UNITED STATES
DEPARTMENT OF THE INTERIOR
BUREAU OF LAND MANAGEMENT
SUNDRY NOTICES AND REPORTS ON WELLS

5. Lease Serial No.	NMMN-66425
6. If Indian, Allottee or Tribe Name	
7. Unit or CA Agreement Name and No.	
8. Well Name and No	Laguna Salado 22 Federal 6H
9. API Well No.	30-015-37371
10. Field and Pool, or Exploratory	Ingle Wells; Delaware
11. County or Parish State	Eddy NM

TYPE OF SUBMISSION	TYPE OF ACTION			
☒ Notice of Intent	☐ Acidize	☐ Deepen	☐ Production (Start/Resume)	☐ Water Shut-Off
☐ Subsequent Report	☐ Alter Casing	☐ Fracture Treat	☐ Reclamation	☐ Well Integrity
☐ Final Abandonment Notice	☐ Casing Repair	☐ New Construction	☐ Recomplete	☒ Other Rig Layout Change
	☐ Change Plans	☐ Plug and Abandon	☐ Temporarily Abandon	
	☐ Convert to Injection	☐ Plug Back	☐ Water Disposal

5,000 PSI CHOKE MANIFOLD

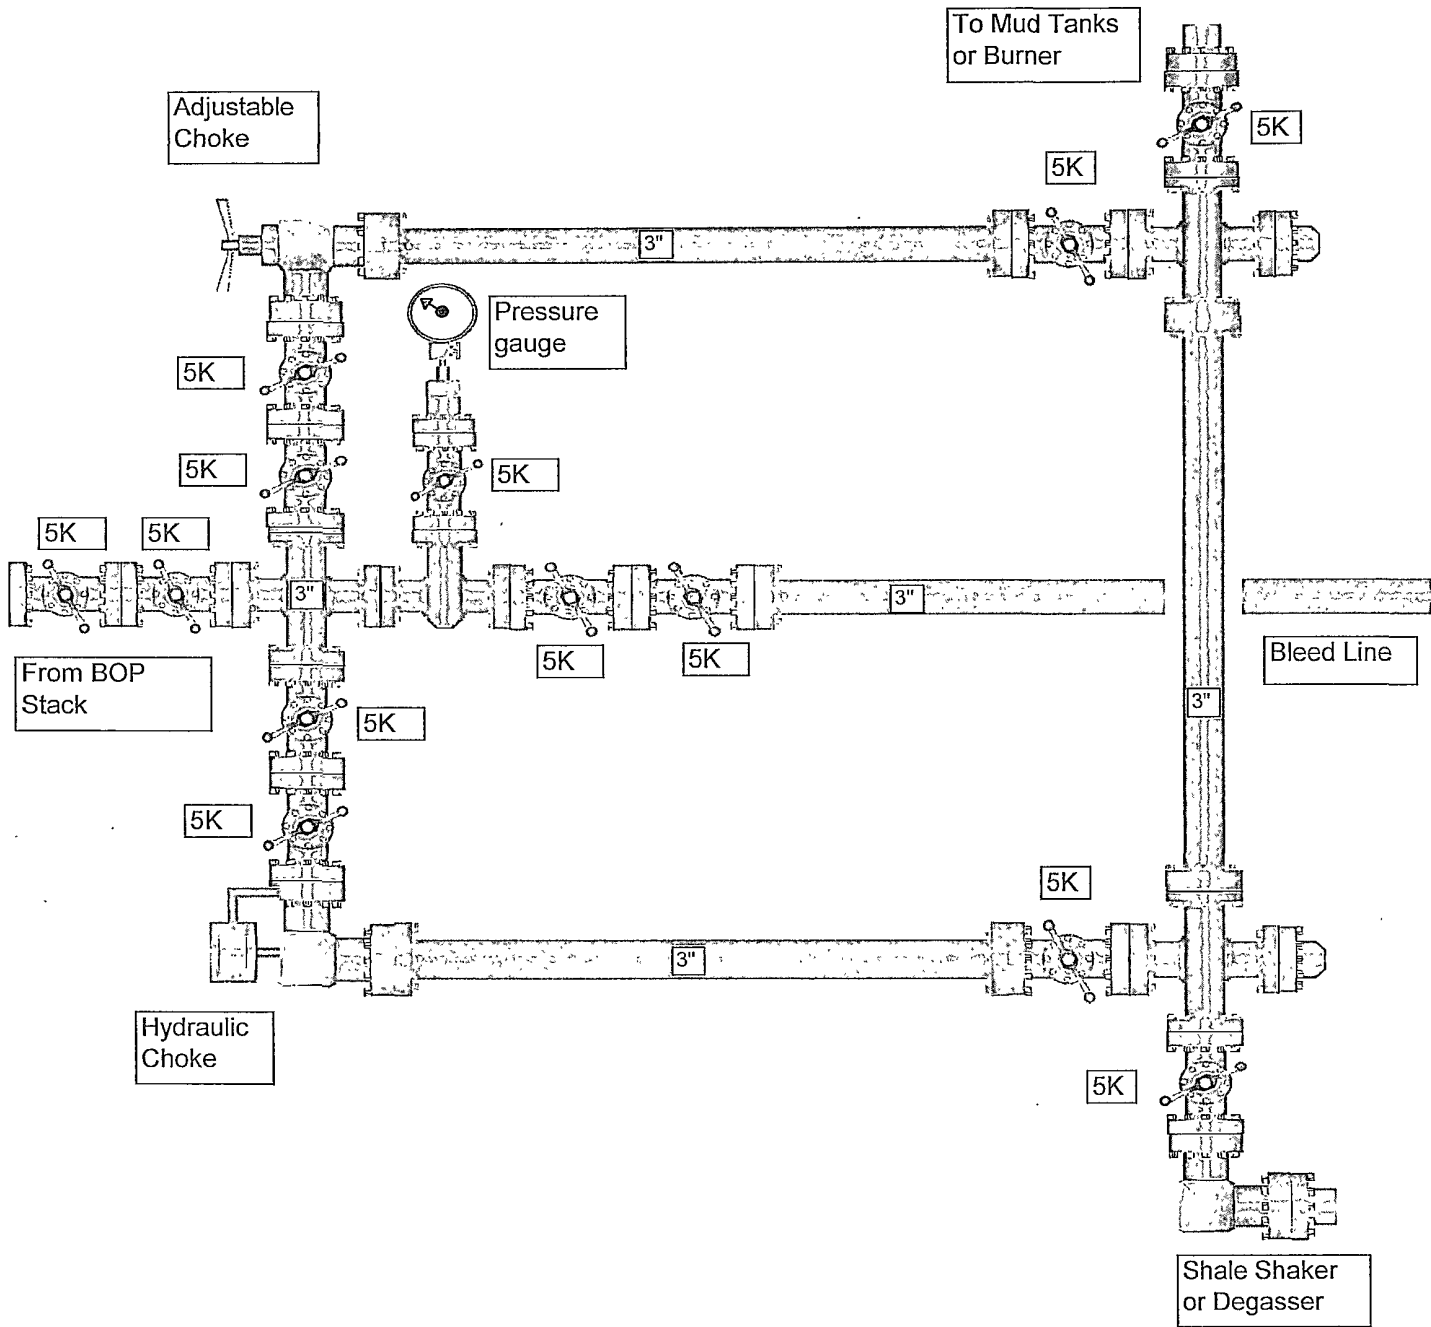
Devon Energy Production Company L. P. respectfully requests to change the rig layout from the McVay #7 to the H & P Rig #214 to drill this well and requests a variance that a co-flex hose may be used between the BOP and the choke manifold. The hose will be kept as straight as possible with minimal turns. CO-Flex Hose Manufacturer: Phoenix Beattie; ~33' (11.43 meters) of co-flex line; 3" coupling w/ 4 1/16" flange on each end - 10,000 psi; Quality Control Inspection & Test Certificate attached; see configuration schematic. Safety clamps are not required since the ends are flanged.

variance approved to use flex line from BOP to choke manifold. Check condition of 4 1/16" flexible line from BOP to choke manifold, replace if exterior is damaged or if line fails test. Line to be as straight as possible with no hard bends.
